**STAFF REPORT 05-12-2021 REGULAR MEETING**

**APPLICATION NUMBERS: 21-7253, 21-7254, 21-7255, 21-7256, 21-7257, 21-7258, 21-7259, 21-7260, 21-7261**

**ADDRESSES: 1501-1567 CHURCH, 1606-1622 CHURCH**

**SCOPE: ERECT NEW PARKING STRUCTURE WITH GROUND-FLOOR RETAIL ON VACANT LOTS AT 1501-1541 CHURCH, ERECT NEW TOWNHOUSES ON VACANT LOTS AT 1606-1622 CHURCH**

Partial north elevation at east end of building. Articulated “window” subdivision (i.e., crossed mullions) at corner openings (e.g., green arrow) is recommended to continue at the featureless openings at the parking deck areas (e.g., red arrow). Other designs are possible.

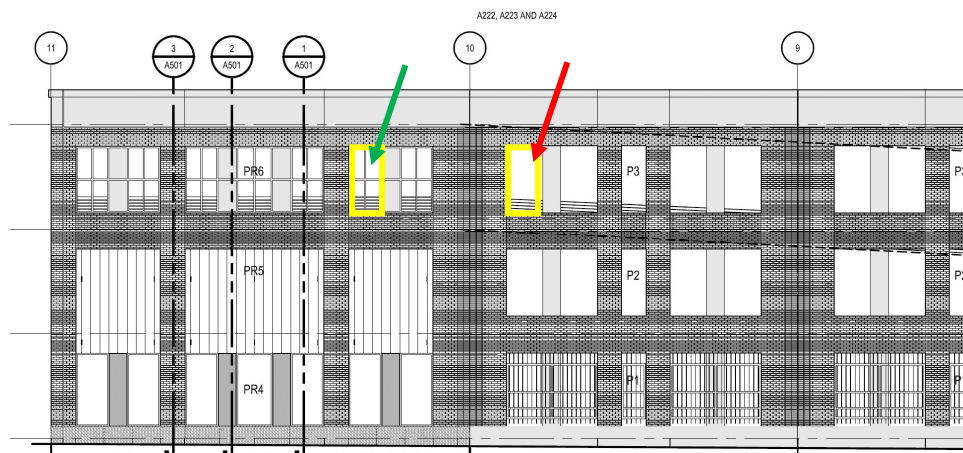
- Consistent with **Element 3** above, staff does make a recommendation to the Commission, as we do with recommendations around other parking structures, that all openings be subdivided and screened, so as not to create gaping, obvious openings disrupting the plane of the building. Such screening should of course be designed to allow the code-required amount of air circulation within the facility, but should be dense enough to obscure or at least de-emphasize the parking usage. Window subdivisions and screening, as added, should be consistent across the building. See image below.

- **Per the above staff analysis concerning a request for additional subdivision and/or screening at the "featureless" openings at the parking structure, the architect has responded to note that the addition of such additional material will reduce the overall ventilation percentage for the building below the code-required 20% (specifically, from 21.5% to 18% overall). Staff is hopeful that alternate options can be discussed with the Commission.**

- That all open-air and otherwise featureless "window" openings serving the parking decks be infilled with window-like subdivisions and/or screening to reinforce the vertical plane of the building and mitigate the appearance of large empty openings. Such subdivisions and treatment will be consistent across all window openings in the building to create a unified composition, subject to staff approval.
